Hexham Long Term Train Stabling Facility Modification 2 (SSI-6090-Mod-2) – Response to Submission

Table 1 DPE comments and response

Table 2 Newcastle City Council comments and response

Table 3 TfNSW comments and response

Attachment D – Updated traffic flow diagrams

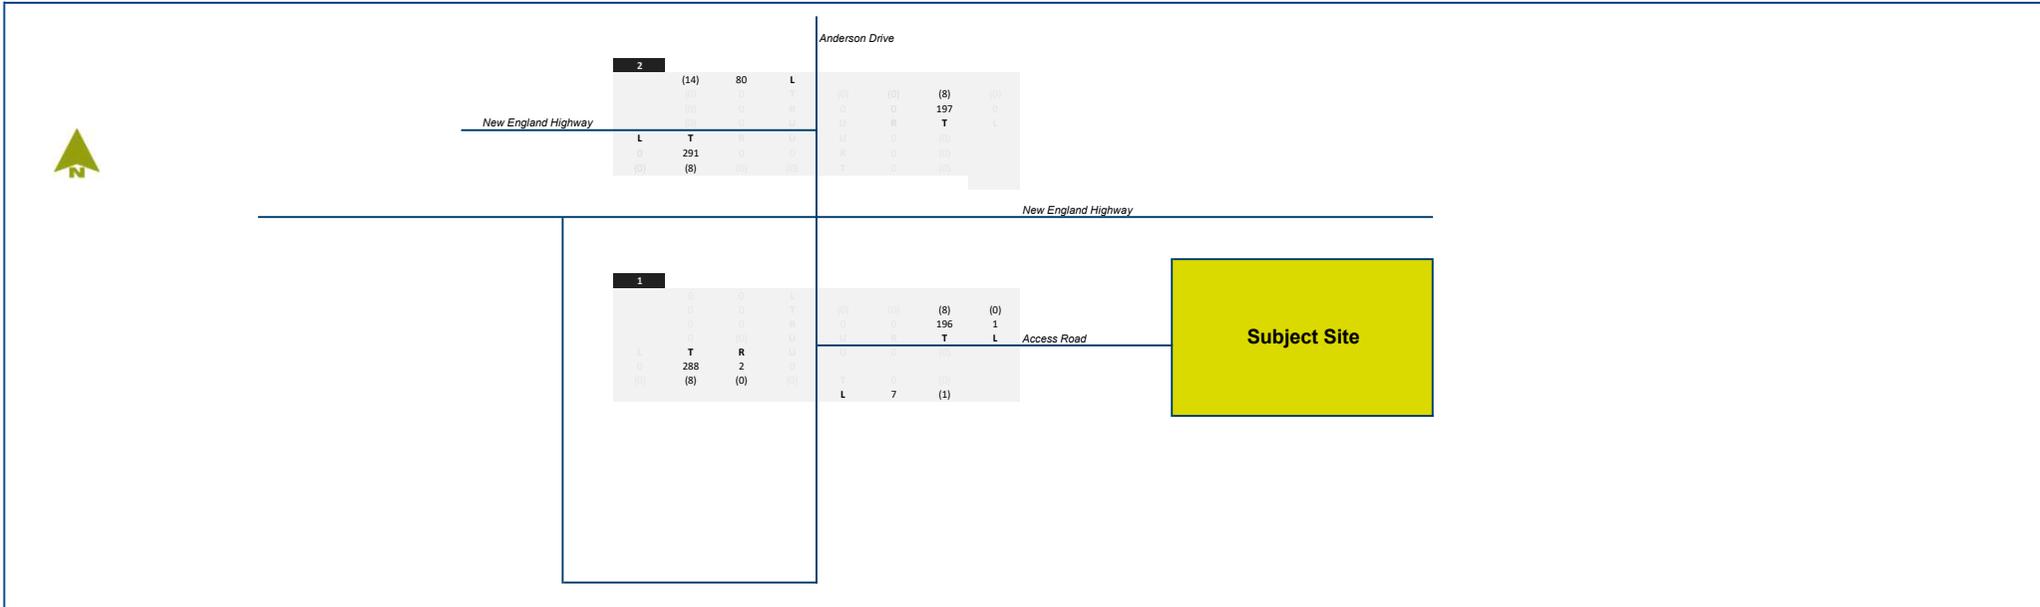
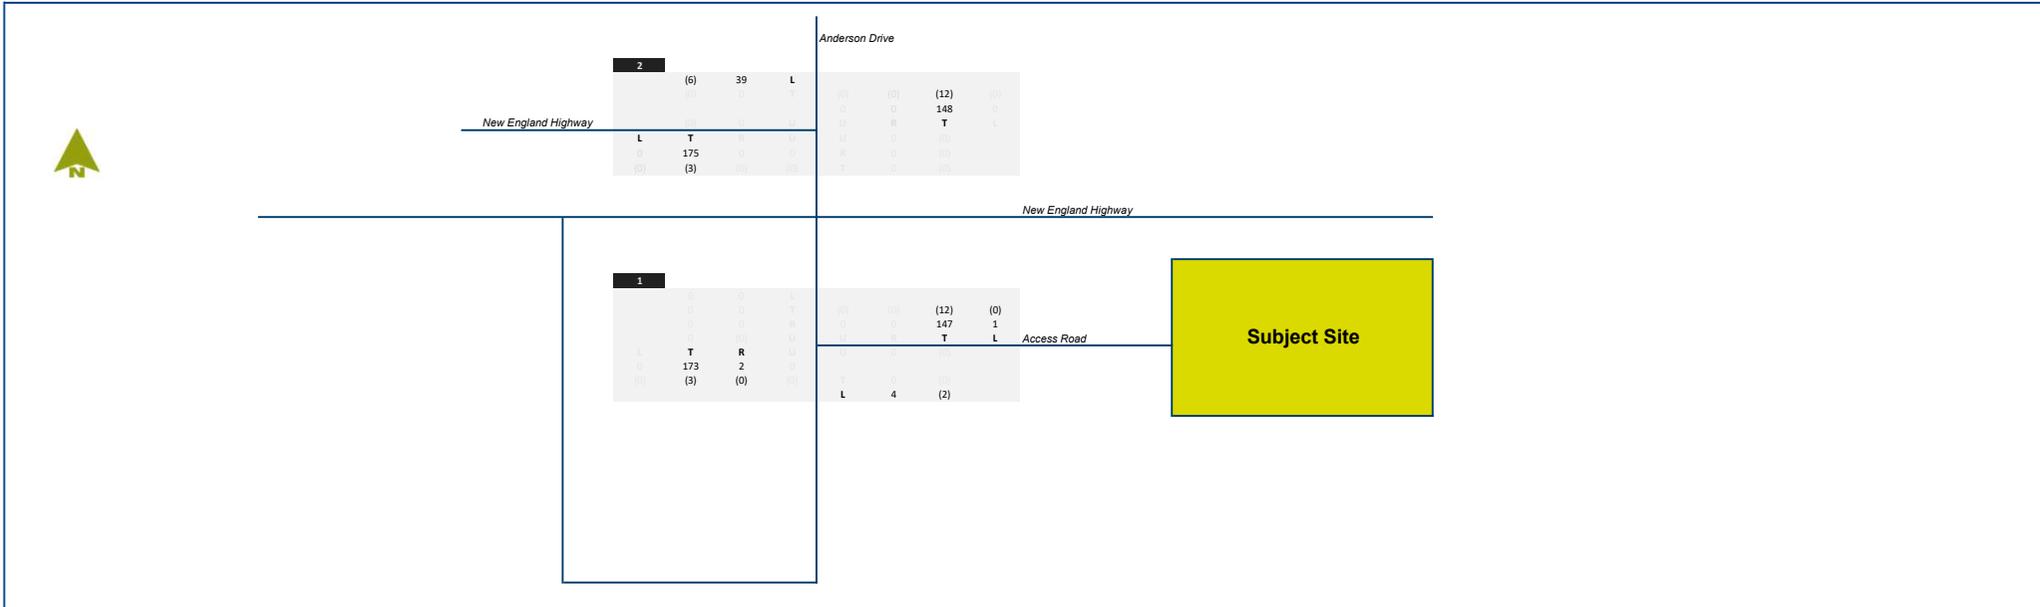
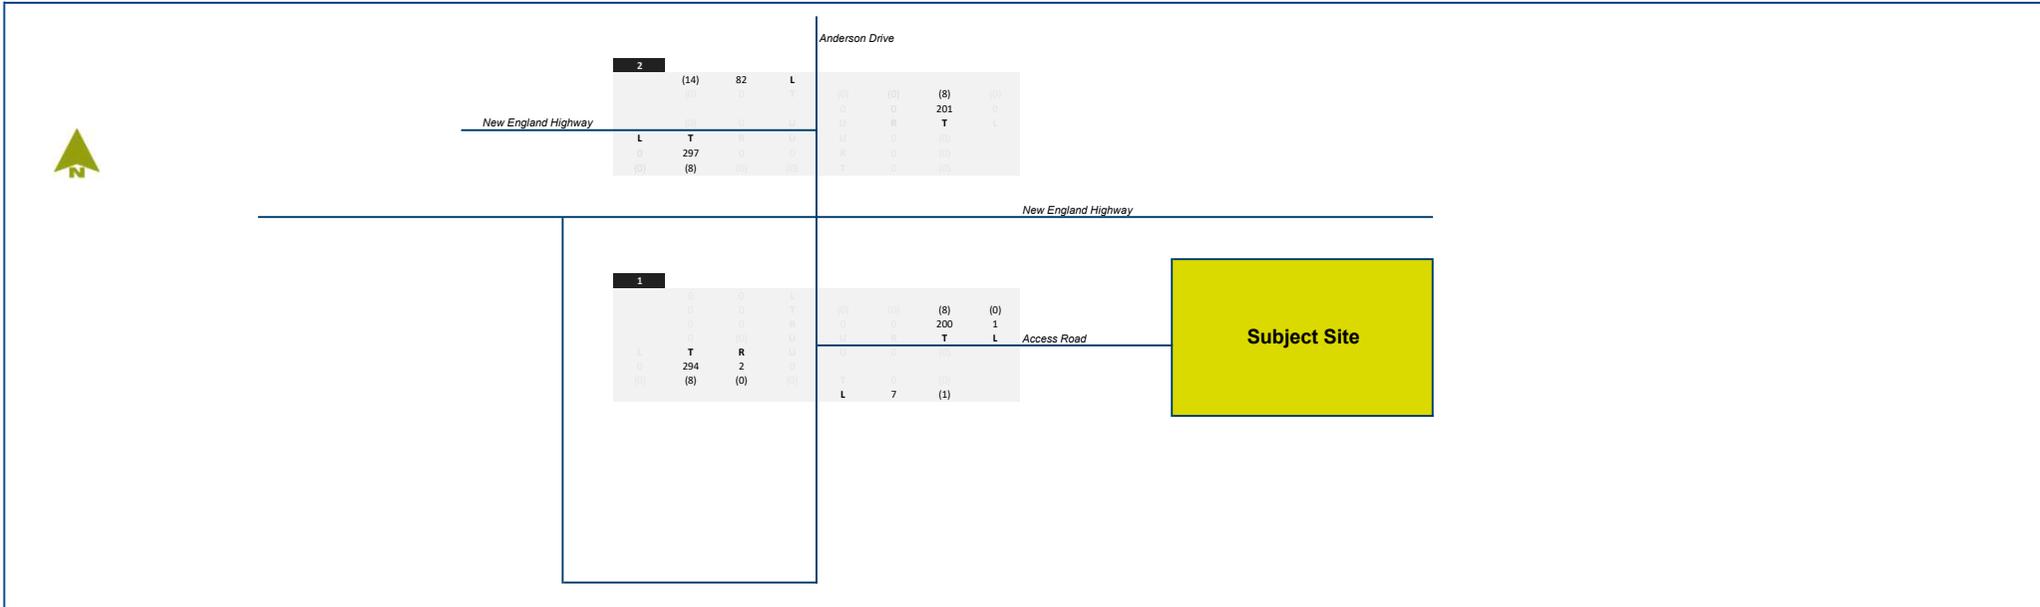
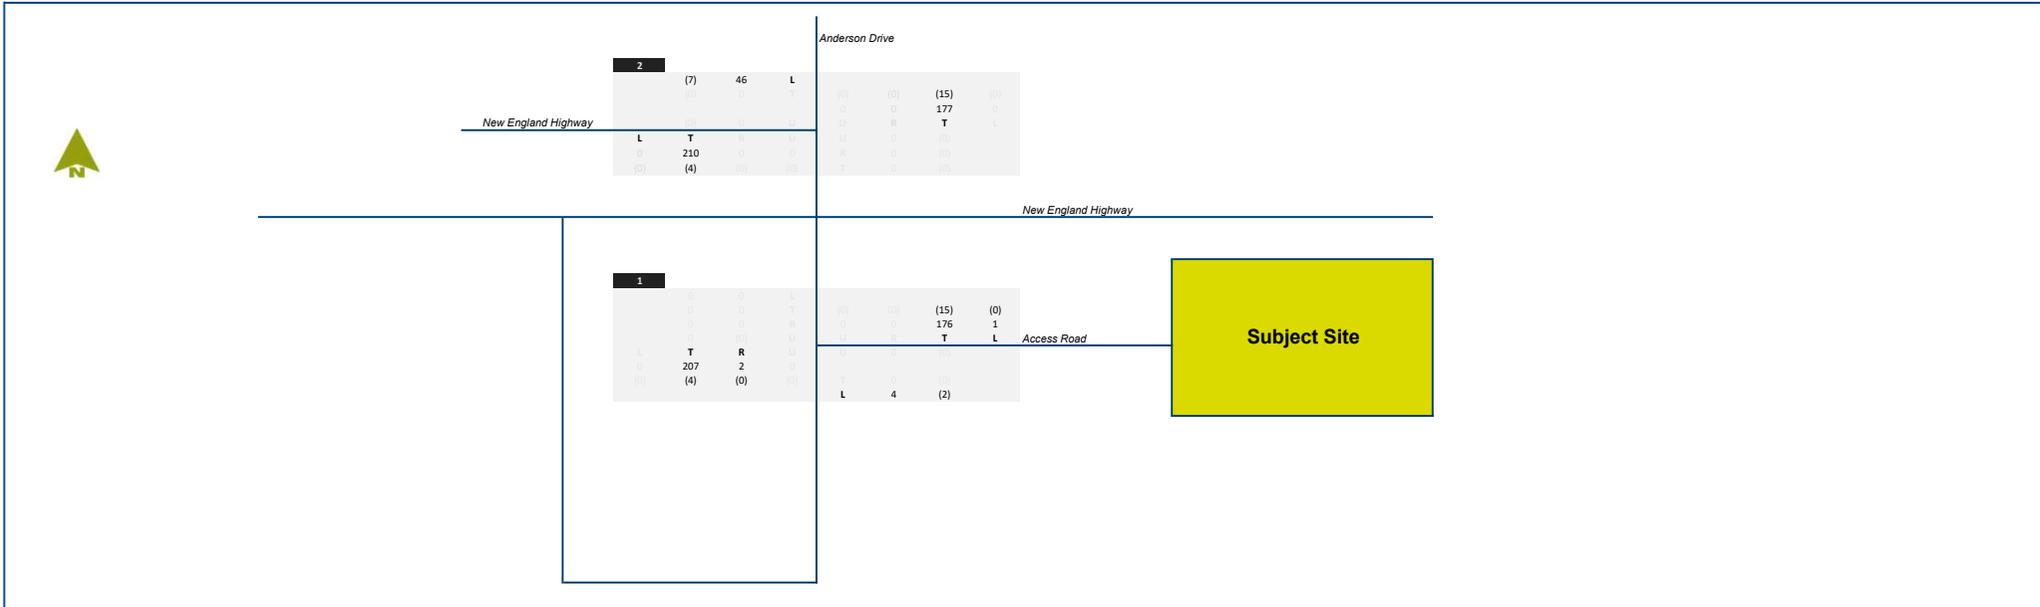
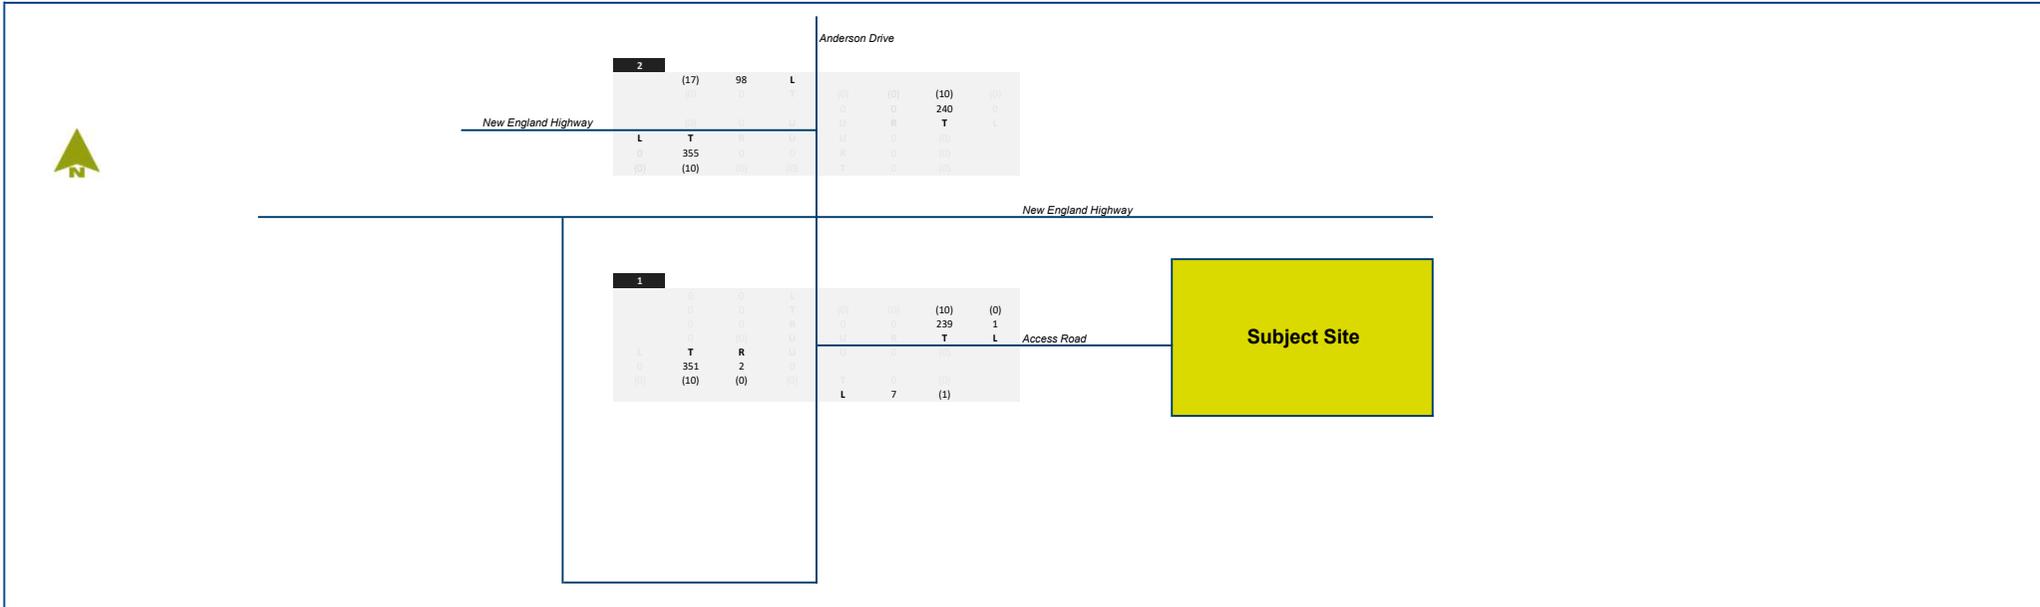
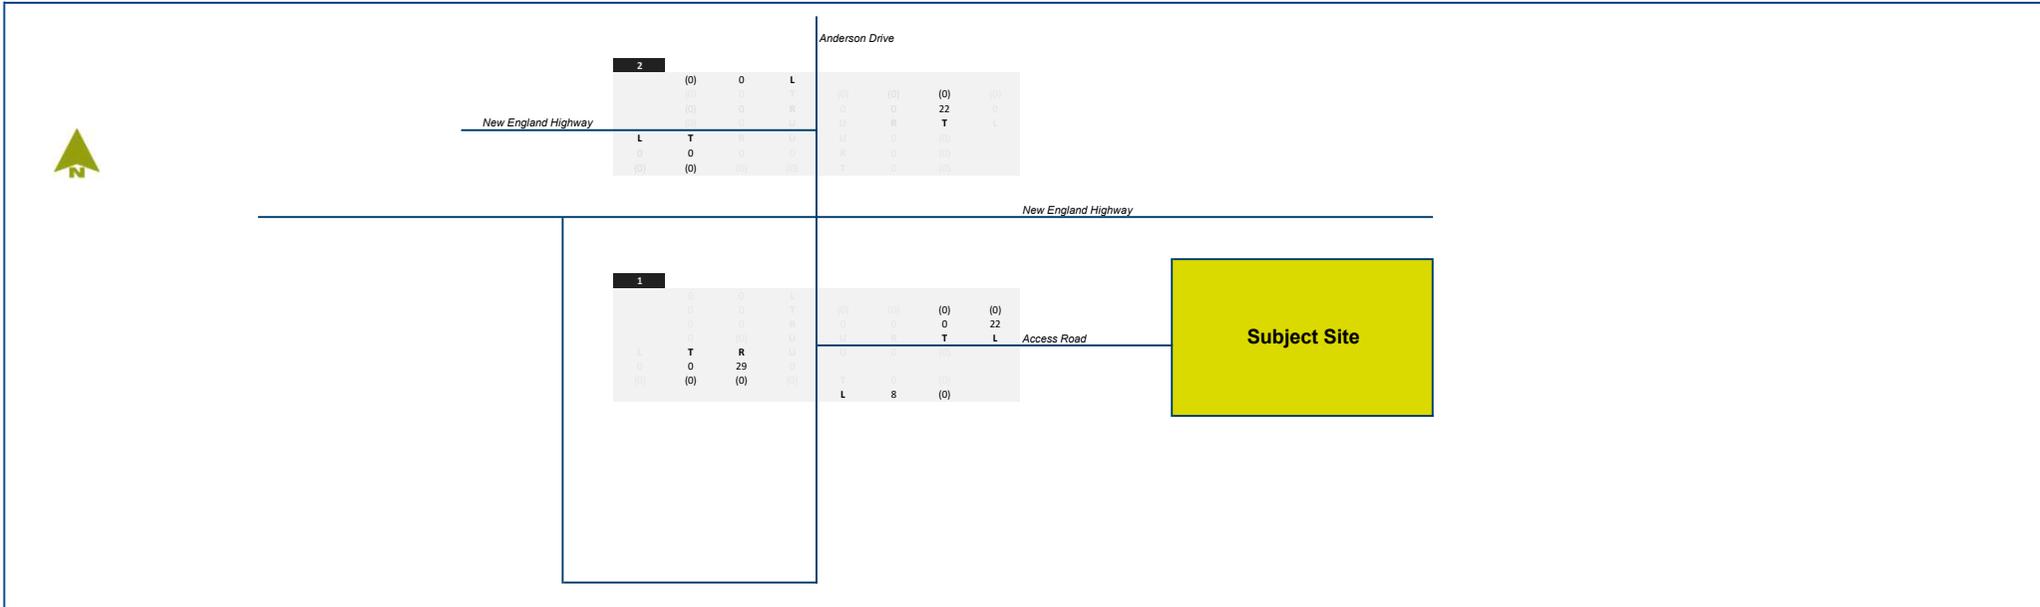
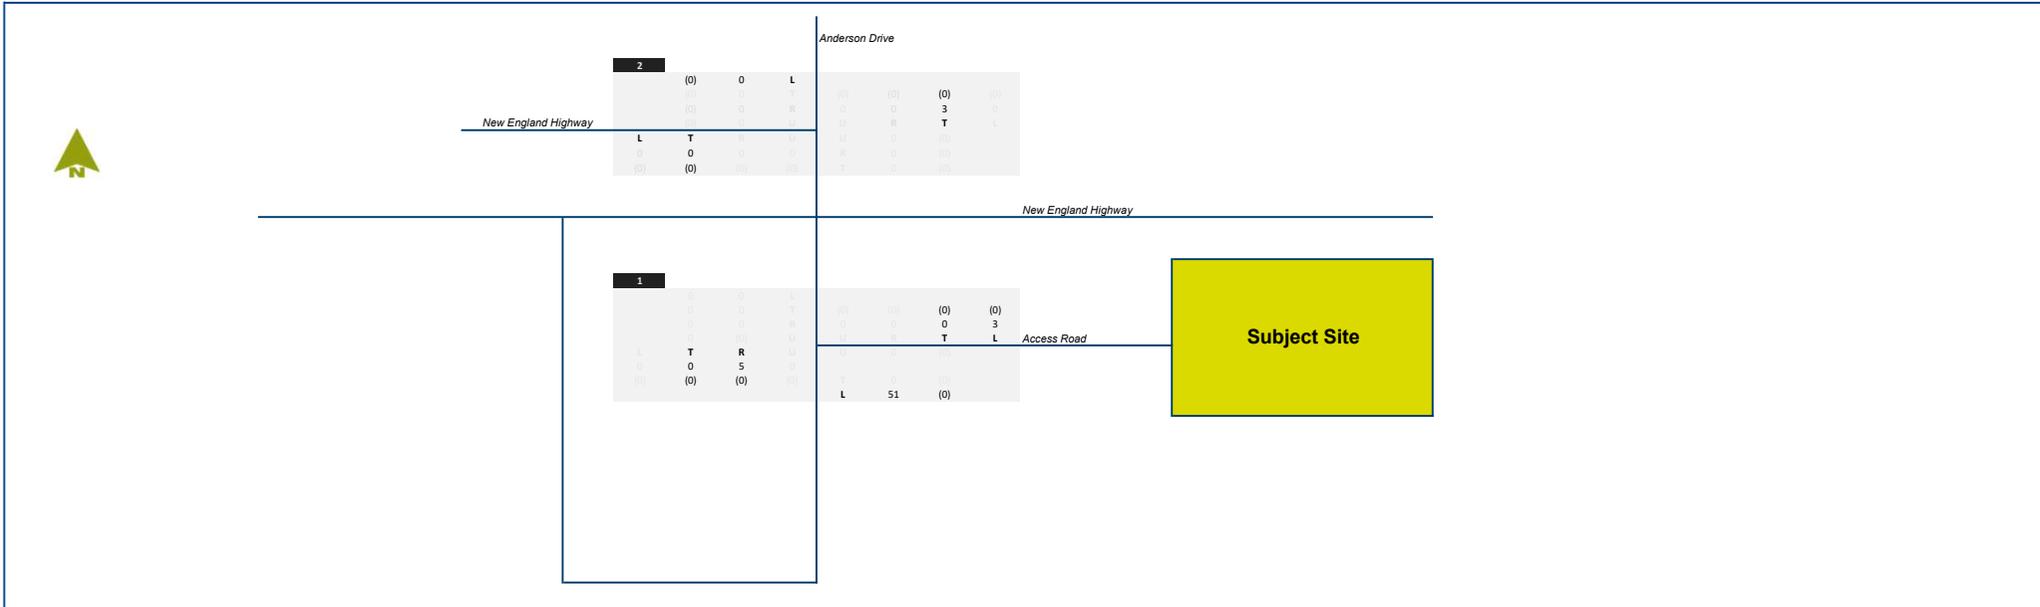
Aspect	Comment	Response	Reference
Intersection model	The submitted Traffic Impact Assessment (TIA) has undertaken an analysis of the current State road network. The model however has identified vehicle movements inconsistent with the current road layout. For example, I1 has no right turn movement out from the Access Road, and I2 has no right turn movements out from the New England Highway off-ramp. These should be amended as part of a revised TIA.	<p>SLR has provided updated traffic flow diagrams (Attachment D of this RtS) which consider the removal (and re-assignment) of the existing and forecast illegal right turn movements at the Tarro interchange. These diagrams also provide a breakdown between light and heavy vehicles.</p> <p>The updated traffic movements have been input into the SIDRA traffic model. Summary output from the revised modelling (Attachment E of this RtS). Updated SIDRA model files are also supplied for review (submitted under separate cover). As identified from the updated SIDRA outputs, the Modification Proposal would, with the redirection of these illegal turns, not result in an increased level of service at the identified intersections. The traffic impacts of the Modification Proposal are therefore considered minor.</p>	Attachment D and Attachment E of this RtS

SLR has provided updated traffic flow diagrams (**Attachment D** of this RtS) which considered the removal (and re-assignment) of the existing and forecast illegal right turn movements at the Tarro interchange. These diagrams also provide a breakdown between light and heavy vehicles.
